U.S. Department
of Transportation
**Federal Highway
Administration**

In Reply Refer To:
HSST-1/B-136A

- ACRYLITE Soundstop TL-4 Noise Barrier System

TITLE: HORIZONTAL RAIL POST CONNECTION	PROJECT NO: 16P0007	FILE NAME: 16P0007-TL4 Modifications	 VISION BUILT
	PROJECT: TL-4 MODIFICATION DRAWINGS FOR FHWA APPROVAL	DRAWN BY: MJR	
	CHECKED BY: GJS	REVISED:	DWG. NO: SK-1

TITLE: ALTERNATE ANCHORAGE DETAILS FOR VARYING BARRIER WALLS	PROJECT NO: 16P0007	FILE NAME: 16P0007-TL4 Modifications	 VISION BUILT
	PROJECT: TL-4 MODIFICATION DRAWINGS FOR FHWA APPROVAL	DRAWN BY: MJR	
	CHECKED BY: GJS	REVISED: APRIL 13, 2016	DWG. NO: SK-10a

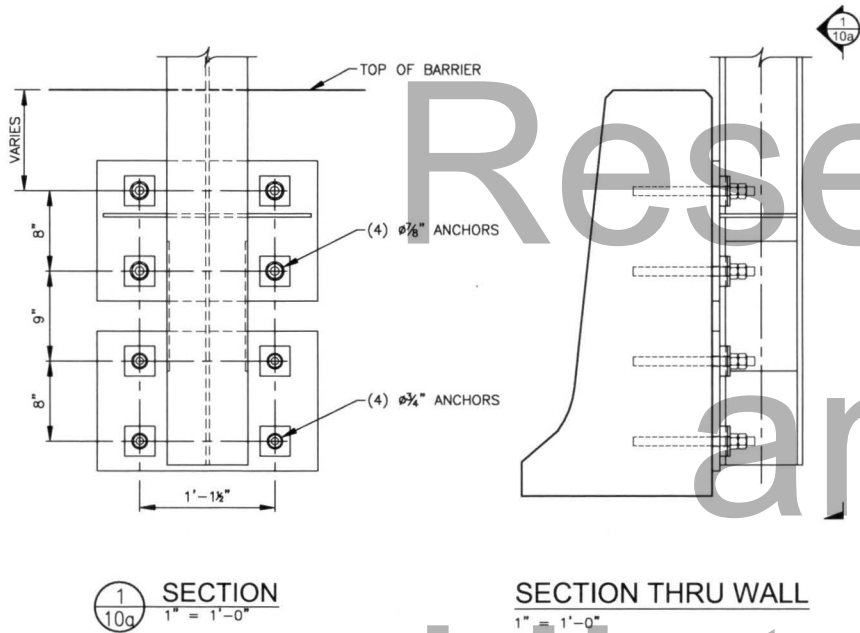
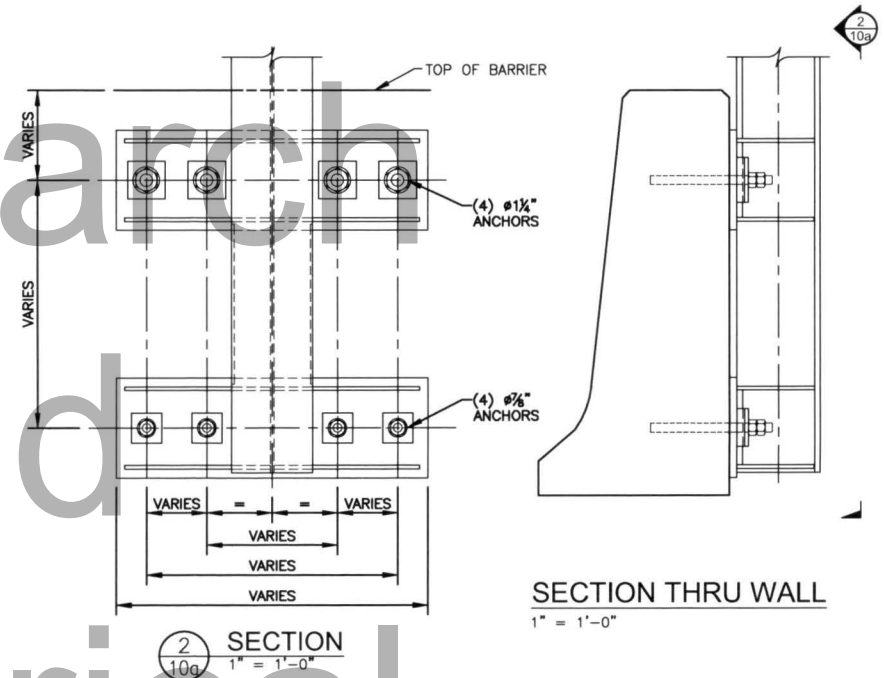
Modification for ACRYLITE Soundstop TL4 noise barrier system to provide alternative post-to-barrier anchorage details.

The need to provide an alternative connection option relates to system attachment to differing parapet geometries, which do not allow for the full development of anchor bolt capacities as the as-tested configuration. In this specific case, the concrete parapet may not be thick enough to provide the minimum 7 1/2" anchor embedment that was used in the as-tested installation. For this reason, the anchor plates have been re-configured and used in combination with larger diameter anchors set with a 5 5/8" minimum embedment. The net impact of the modification results in greater anchor bolt capacity as compared to the as-tested configuration. The engineering analysis is attached as Mod010 Evonik TL-4 Alternate Anchorage Comparison.pdf.

This proposal requests eligibility to use the alternative connection option to anchor the posts to the parapet as well as future modifications on the basis that an engineering analysis is performed to similarly show that the anchorage configuration results in greater anchor bolt and anchor plate capacity as compared to the as-tested configuration.
